SWIM PROJECT PROFILE		File No. : 194
Regist. No. : Agency No. : BSWM-113	Name: LABOON SWIP	
Region: 8	Province: SOUTHERN LEYTE	Municipality: MAASIN
Present Status: 1. Pre-F/S( )    ② F/S(1983)    ③ D/D(1983)		
Purpose: Major : Irrigation Incidental : IF, FC, WM		
Project Feature:

SWIM PROJECT PROFILE		File No. : 195
Regist. No. : Agency No. : BSWM-114	Name: POLANQUI SWIP	
Region: 8	Province: EASTERN SAMAR	Municipality: TAFT
Present Status: 1. Pre-F/S( ) ② F/S(1983) ③ D/D(1983)		
Purposo: Major : Irrigation Incidental : IF, FC, WM		
Project Feature:

SWIM PROJECT PROFILE		File No. : 199
Regist. No. : Agency No. : BSWM-119	Name: LUNGNOT SWIP	
Region: 9	Province: ZAMBOANGA DEL SUR	Municipality: DUMALINAO
Present Status: 1. Pre-F/S( )    ② F/S(1983)    ③ D/D(1983)		
Purpose: Major : Irrigation Incidental : IF, FC, WM		
Project Feature:

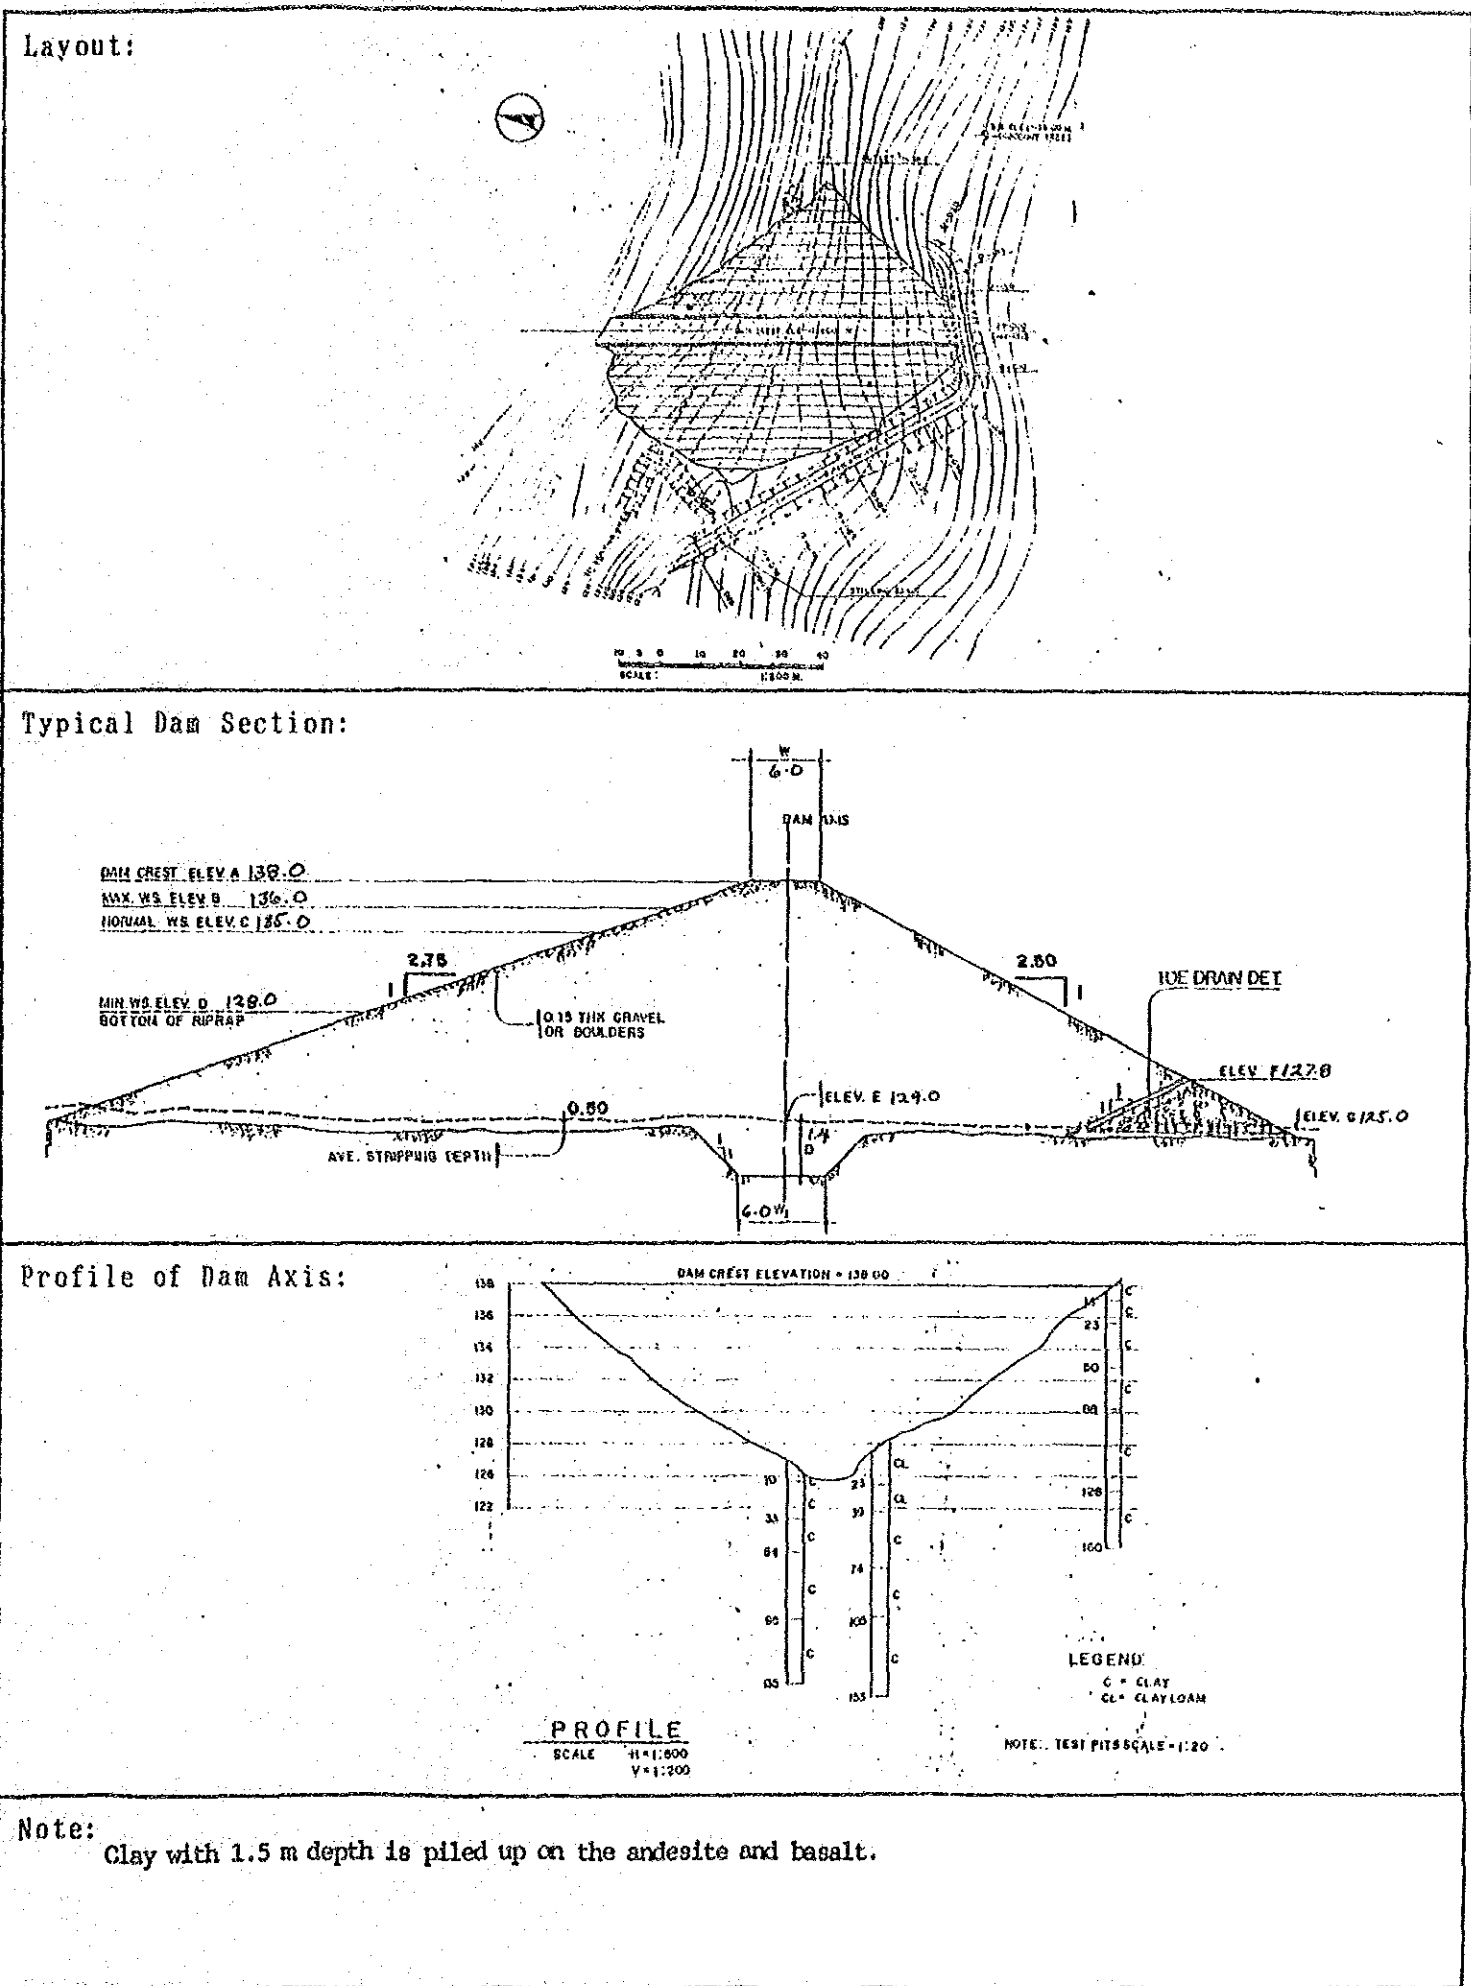
6. Inland Fishery	Annual Production	5 ton/year
Technical Assessment:		
1. Survey and Investigation: Depth of test pit or auger boring is not enough. Bearing capacity and permeability are not measured. Available volume for dam embankment shall be studied before construction.

2. Planning Environmental conservation plan is not formulated.		
3. Design Depth of core trench shall be modified during construction. Stability of upstream slope of the dam shall be checked. Center line of the spillway shall be shifted to left side. Weir shall be provided in the spillway.

SWIM PROJECT PROFILE		File No. : 200
Regist. No. : Agency No. : BSWM-120	Name : LAMARE I SWIP	
Region : 9	Province : ZAMBOANGA DEL SUR	Municipality : BAYOG
Present Status: 1. Pre-F/S( ) (2) F/S(1983) (3) D/D(1983)		
Purpose: Major : Irrigation Incidental : IF, FC, WM		
Project Feature:

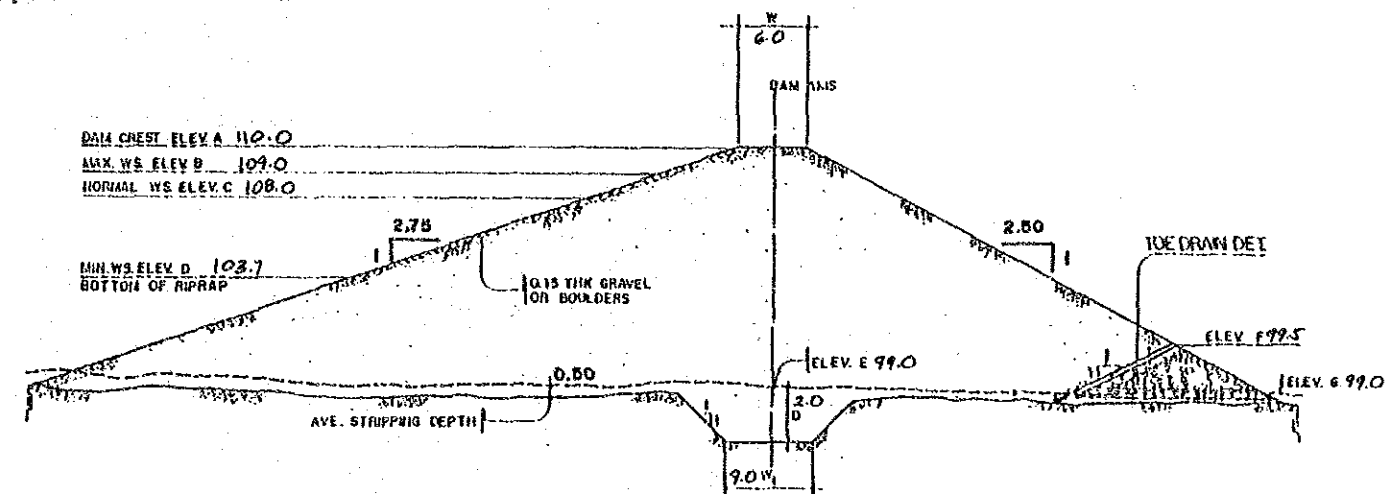
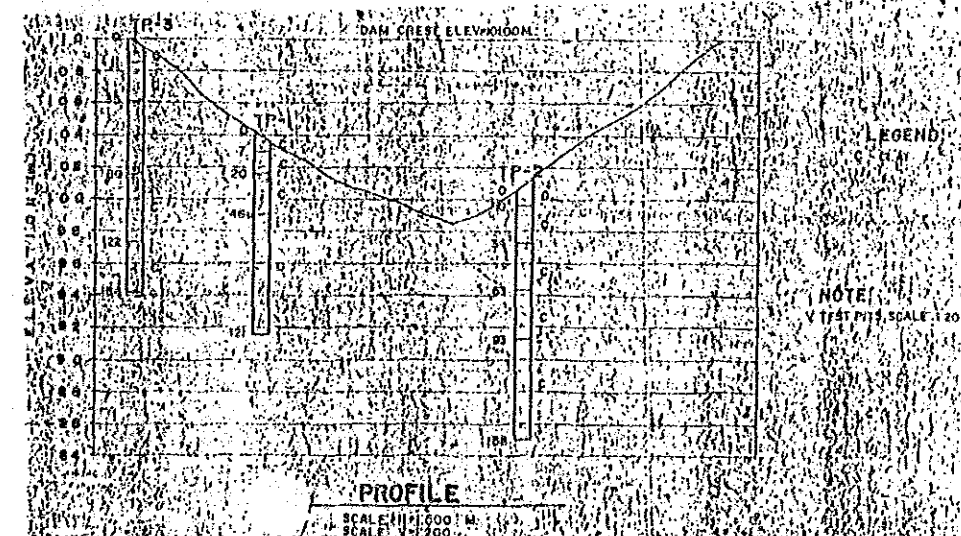
6. Inland Fishery	Annual Production :	3 ton/year
Technical Assessment:		
1. Survey and Investigation: Depth of test pit or auger boring is not enough. Bearing capacity and permeability are not measured. Available volume for dam embankment shall be studied before construction.

2. Planning Environmental conservation plan is not formulated.		
3. Design Depth of core trench shall be modified during construction. Stability of upstream slope of the dam shall be checked. Center line of the spillway shall be shifted to left side. Weir shall be provided in the spillway. Center line of conduit is recommended to be straight.

SWIM PROJECT PROFILE		File No. : 201
Regist. No. : Agency No. : BSWM-121	Name: LAMARE II SWIP	
Region: 9	Province: ZAMBOANGA DEL SUR	Municipality: BAYOG
Present Status: 1. Pre-F/S( )    ② F/S(1983)    ③ D/D(1983)		
Purpose: Major : Irrigation Incidental : IF, FC, WM		
Project Feature:

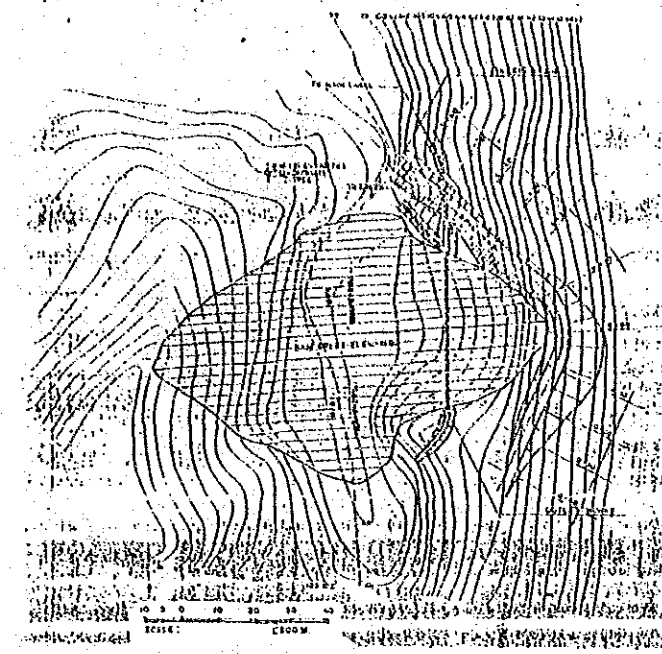
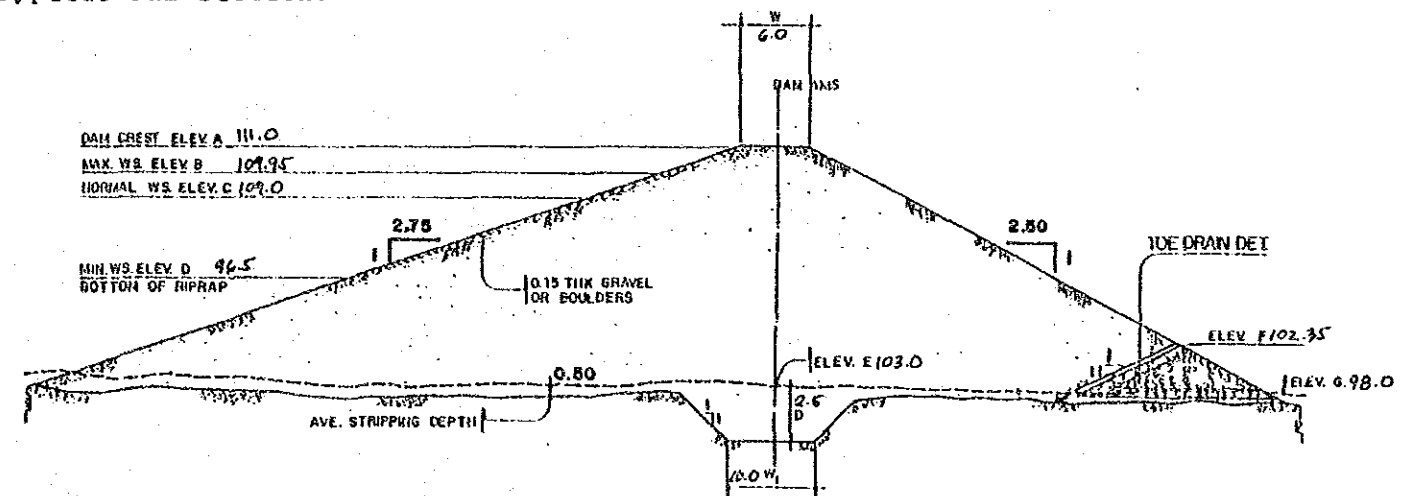
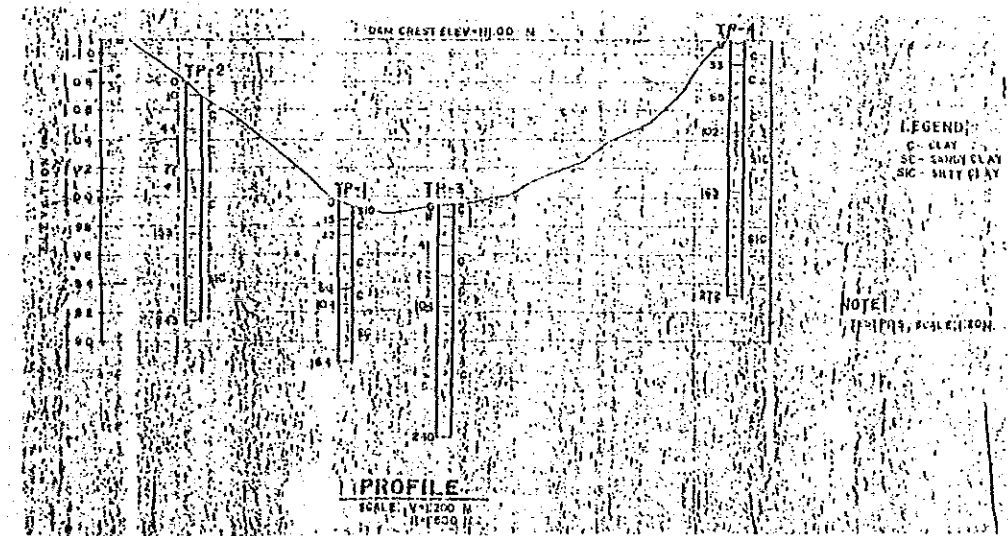
6. Inland Fishery	: Annual Production	: 3 ton/year
Technical Assessment:		
1. Survey and Investigation: Depth of test pit or auger boring is not enough. Bearing capacity and permeability are not measured. Available volume for dam embankment shall be studied before construction.

2. Planning Environmental conservation plan is not formulated.		
3. Design Depth of core trench shall be modified during construction. Stability of upstream slope of the dam shall be checked. Center line of the spillway shall be shifted to right side. Weir shall be provided in the spillway.

SWIM PROJECT PROFILE		File No. : 202
Regist. No. : Agency No. : BSWM-122	Name: BUENAVISTA SWIP	
Region: 9	Province: ZAMBOANGA DEL SUR	Municipality: CURUAN
Present Status: 1. Pre-F/S( )    ② F/S(1983)    ③ D/D(1983)		
Purpose: Major : Irrigation Incidental : IF, FC, WM		
Project Feature:

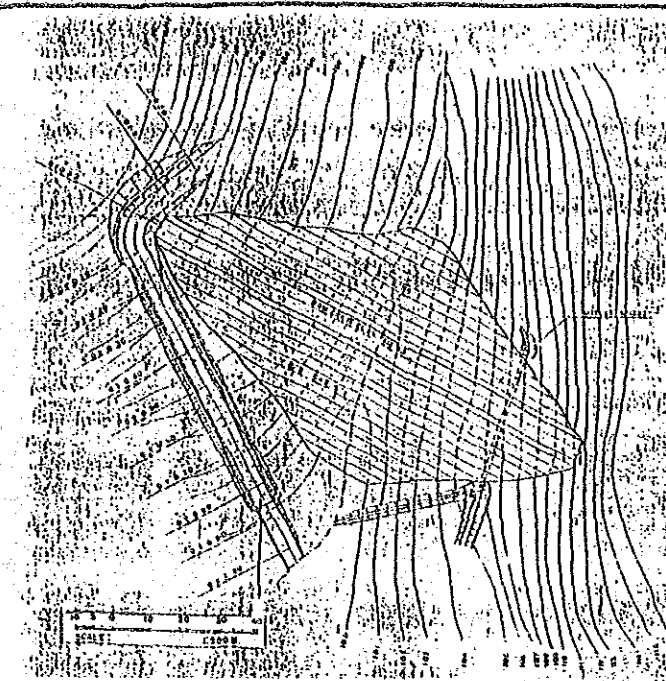
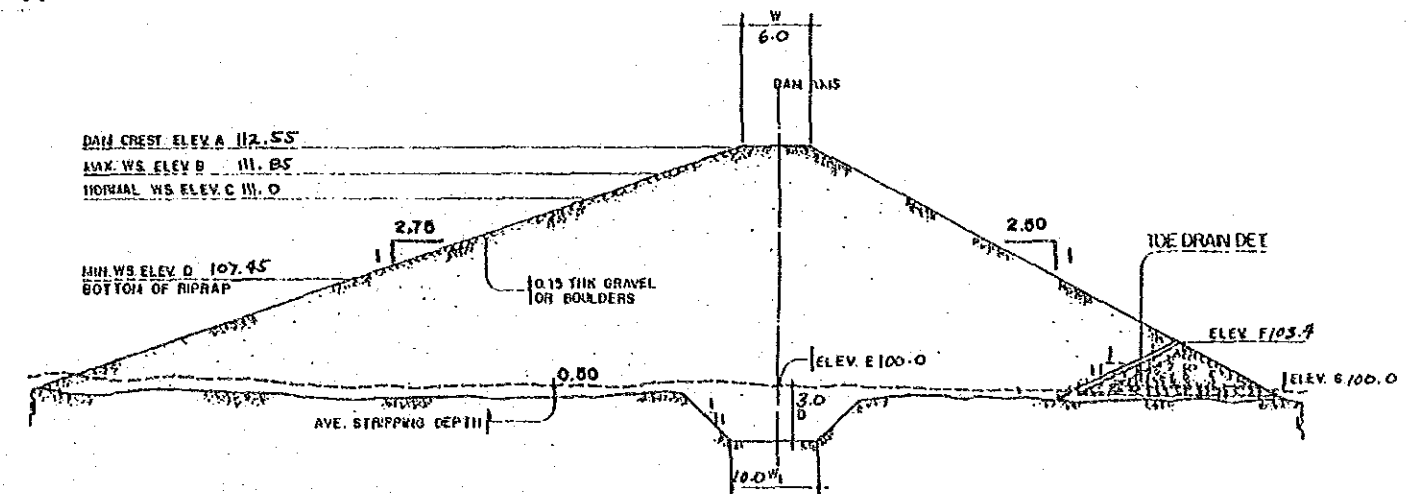
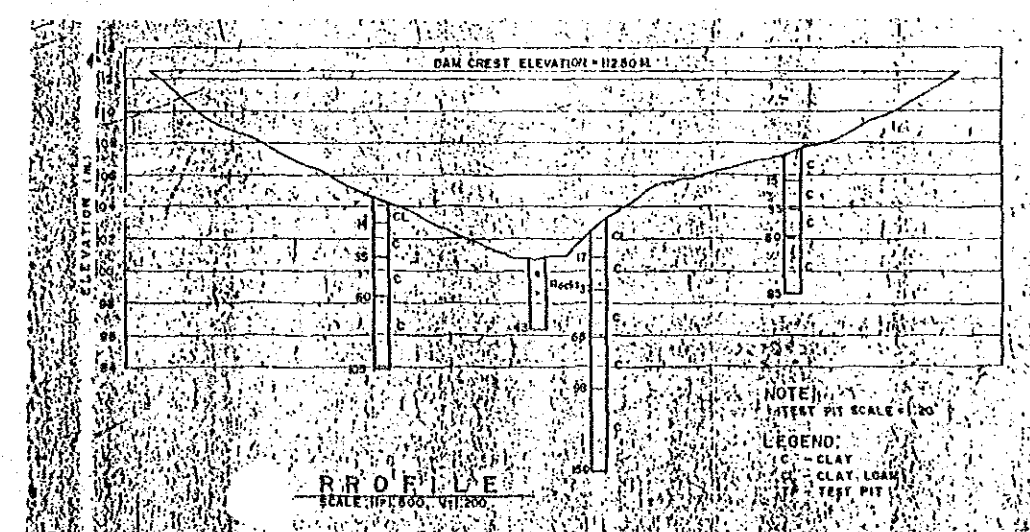
6. Inland Fishery	: Annual Production	: 3 ton/year
Technical Assessment:		
1. Survey and Investigation: Depth of test pit or auger boring is not enough. Bearing capacity and permeability are not measured. Available volume for dam embankment shall be studied before construction.

2. Planning Environmental coservation plan is not formulated.		
3. Design Depth of core trench shall be modified during construction. Stability of upstream slope of the dam shall be checked. Center line of the spillway shall be shifted to right side. Weir shall be provided in the spillway.

SWIM PROJECT PROFILE		File No. : 203
Regist. No. : Agency No. : BSWM-123	Name: GOLING SWIP	
Region: 9	Province: ZAMBOANGA DEL SUR	Municipality: DIPLAHAN
Present Status: 1. Pre-F/S( ) (2) F/S(1983) (3) D/D(1983)		
Purpose: Major : Irrigation Incidental : IF, FC, WM		
Project Feature:

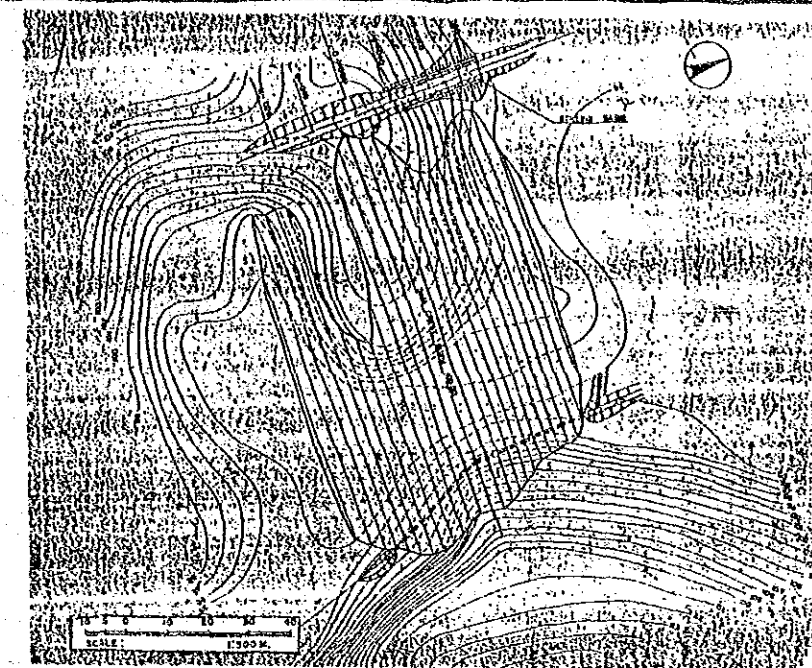
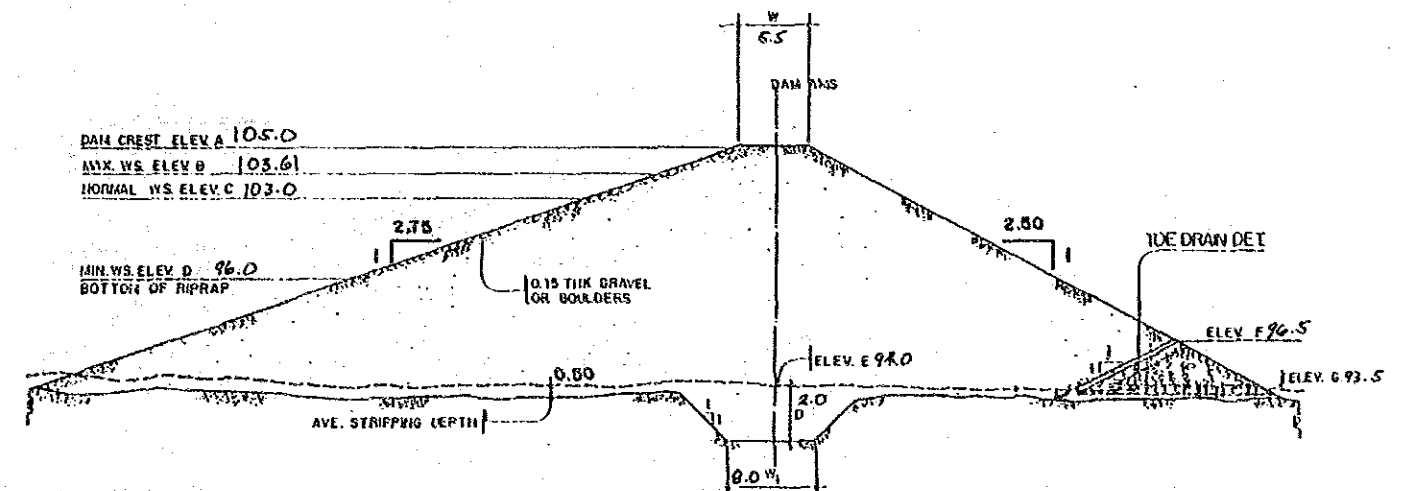
6. Inland Fishery	: Annual Production	: 3 ton/year
Technical Assessment:		
1. Survey and Investigation: Depth of test pit or auger boring is not enough. Bearing capacity and permeability are not measured. Available volume for dam embankment shall be studied before construction.

2. Planning Environmental conservation plan is not formulated.		
3. Design Depth of core trench shall be modified during construction. Stability of upstream slope of the dam shall be checked. Center line of the spillway shall be shifted to left side. Weir shall be provided in the spillway. Center line of conduit is recommended to be straight.
